RESPONSE TO SUBMISSIONS

Kurnell Refinery Conversion

September 2013

Date: **September 2013**
Reference: 43177836/02/02
Status: FINAL

Figure: 1-1
Rev. A A4

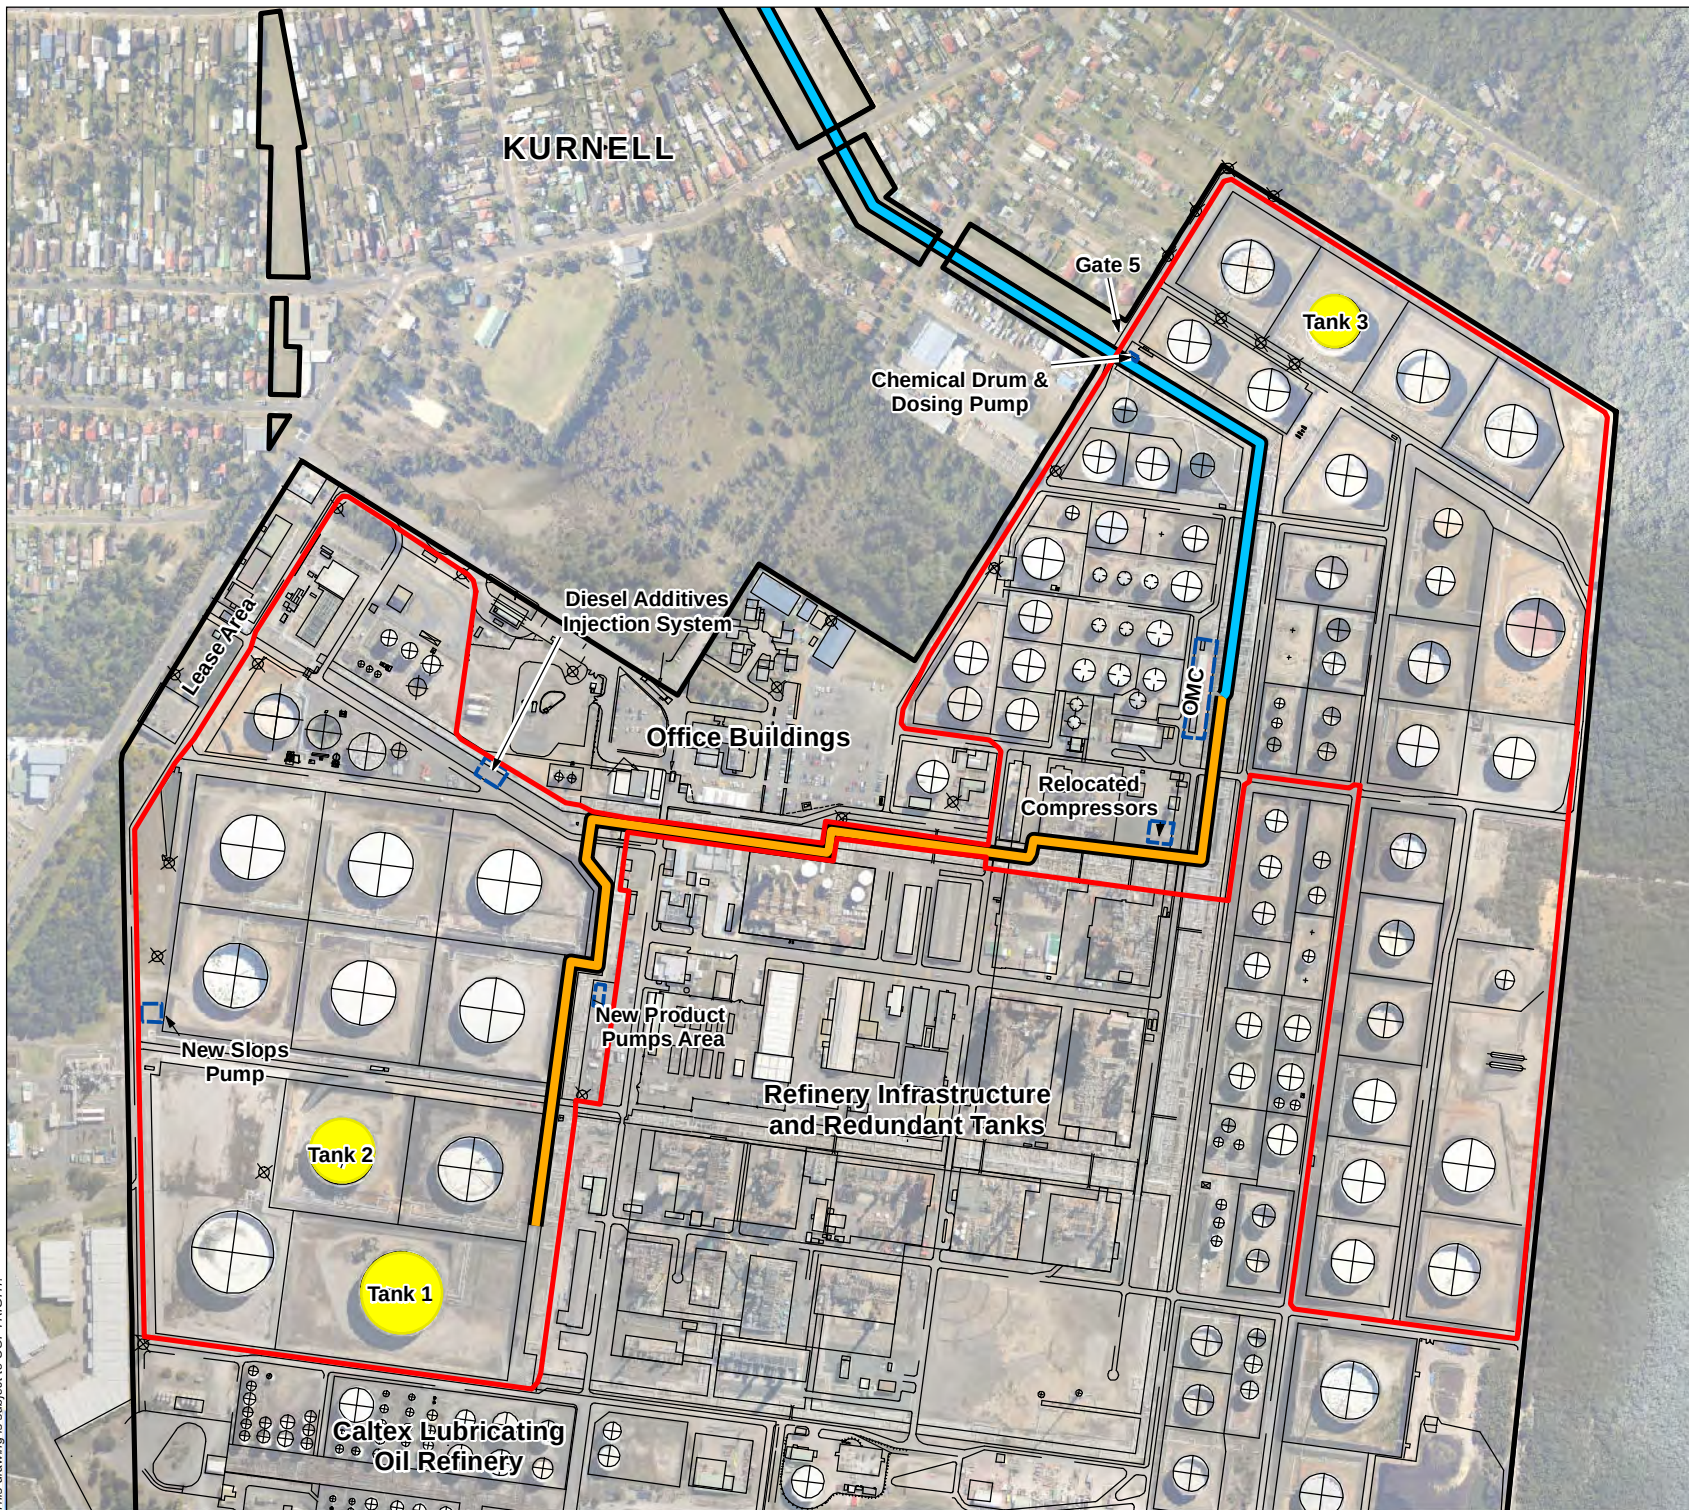
Since the exhibition of the EIS, a minor design change has been proposed by Caltex. Caltex is now proposing to install external domes on top of three of the tanks within the Project Area. The purpose of these domes is to further ensure that small amounts of rainwater do not enter these tanks and contaminate the product during heavy rainfall events. At present the majority of the product storage tanks on the Site have floating roofs. These roofs keep out the vast majority of the rainwater, however during heavy and prolonged rain events very small amounts of water can enter the tanks and affect the quality of the finished product. This water is removed from the finished product through a number of processes on-site, however Caltex would like to provide increased protection to three tanks to ensure that enough quality product is available to the NSW and ACT market.

The potential visual impact of the increase in tank height is the key environmental aspect requiring further assessment. As such, the assessment has included three photomontages to compare the appearance of the existing Site to the appearance of the Site once the heights of the tanks have been increased.
